**CHEMICAL SALES COMPANY SUPERFUND SITE  
OPERABLE UNIT I - PLUME AREA  
EXPLANATION OF SIGNIFICANT DIFFERENCES**

**March 2000**

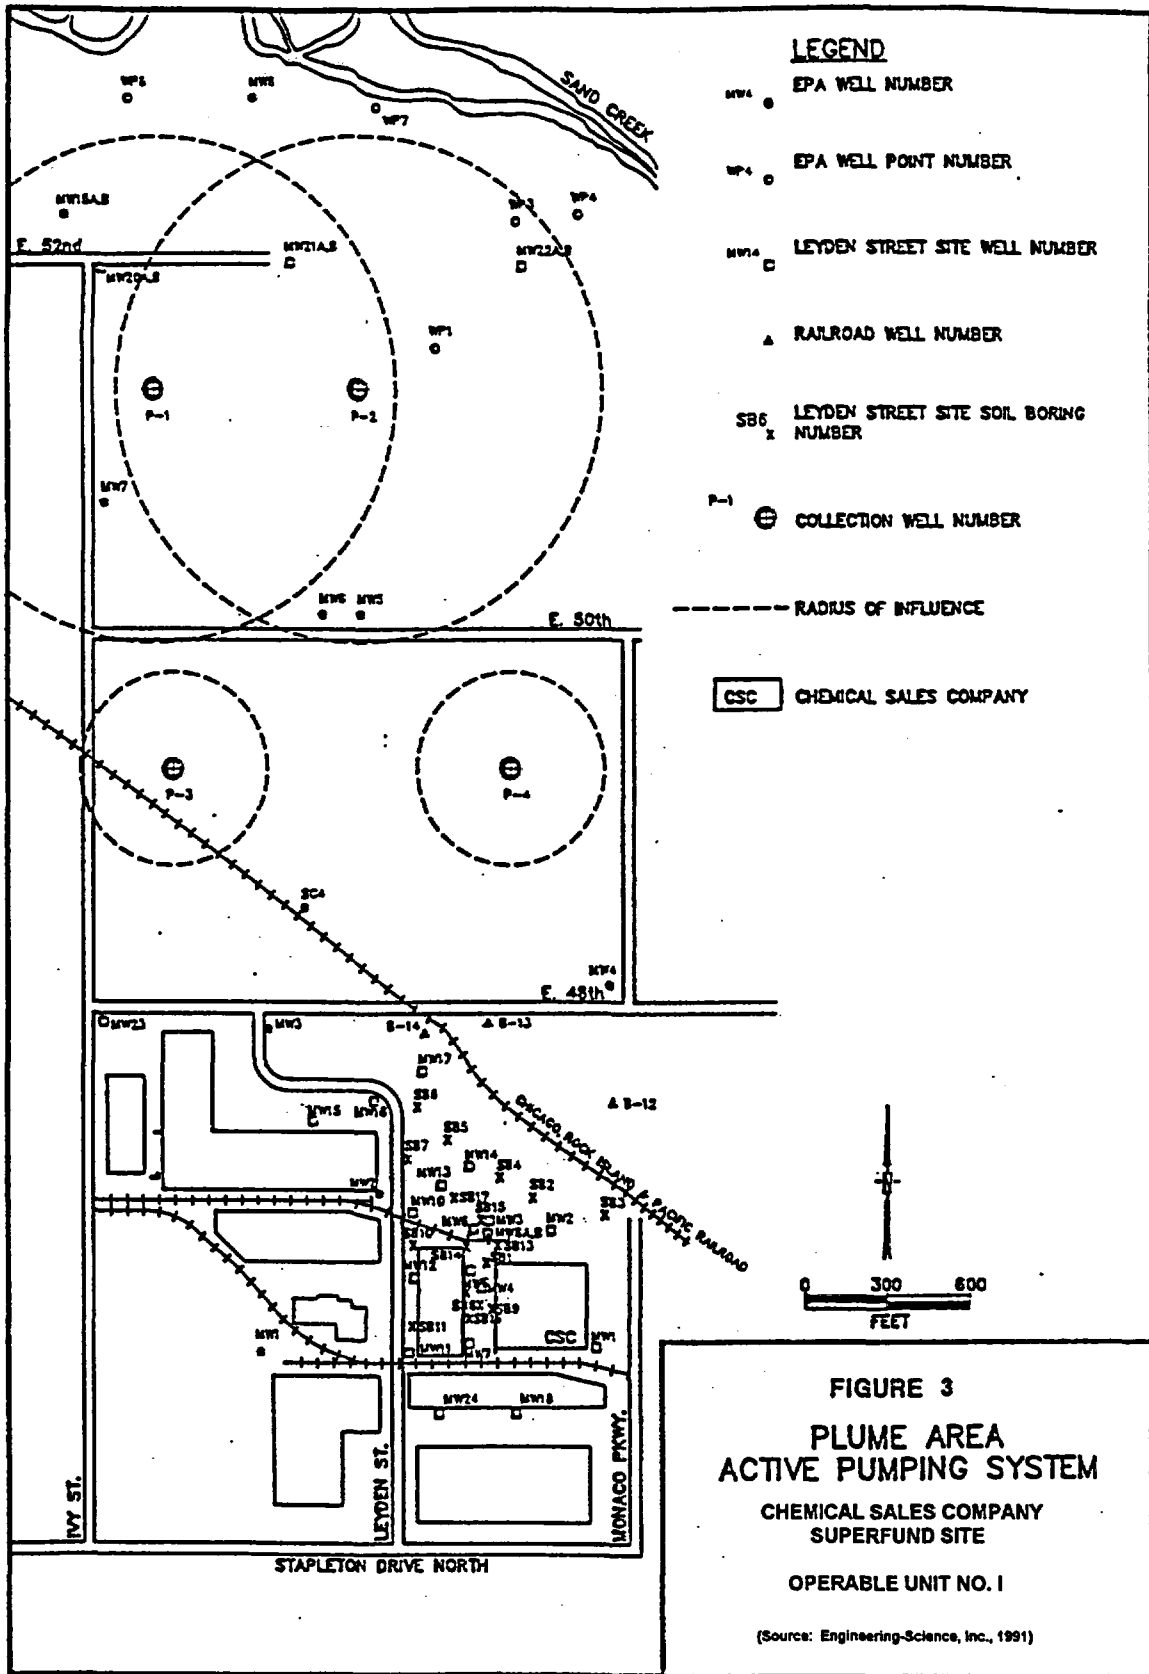
- ▶ Monitoring ground water, discharged treated water and air;
- ▶ Notification by the Colorado State Engineer's Office of the potential health risks associated with use of contaminated ground water upon request for an alluvial well permit within the OU1 area;
- ▶ High volume (1,000 gpm) ground water extraction within the CSC plume area (area north of East 48<sup>th</sup> Avenue and south of Sand Creek);
- ▶ Treatment of contaminated ground water with an air stripping tower located near East 52<sup>nd</sup> Avenue; and
- ▶ Reinfiltration of treated ground water through discharge into a trench or gravel pit for the plume area.

Remedial design ground-water pumping tests showed that achievable pumping rates were 10 to 20 times less than estimates from the RI/FS (7 versus 80 gpm for the shallow zone and 0.25 versus 5 gpm for the deep zone). Even with 61 wells instead of the four required by the ROD, the ground water extraction rate was reduced from 1,000 gpm required by the ROD to 375 gpm.

**Selected Option: Monitored Natural Attenuation.** The selection of monitored natural attenuation will meet all applicable or relevant and appropriate requirements identified in the ROD. There are no action-specific or location-specific requirements for monitored natural attenuation. Chemical-specific requirements, including federal MCLs and State of Colorado Basic Standards for Ground Water apply, and would be met in approximately the same time frame that pumping and treatment would require, when uncertainty in the sophisticated model is considered. The ground water remediation levels identified in the ROD remain unchanged. Ground water will be monitored until remediation levels have been achieved.
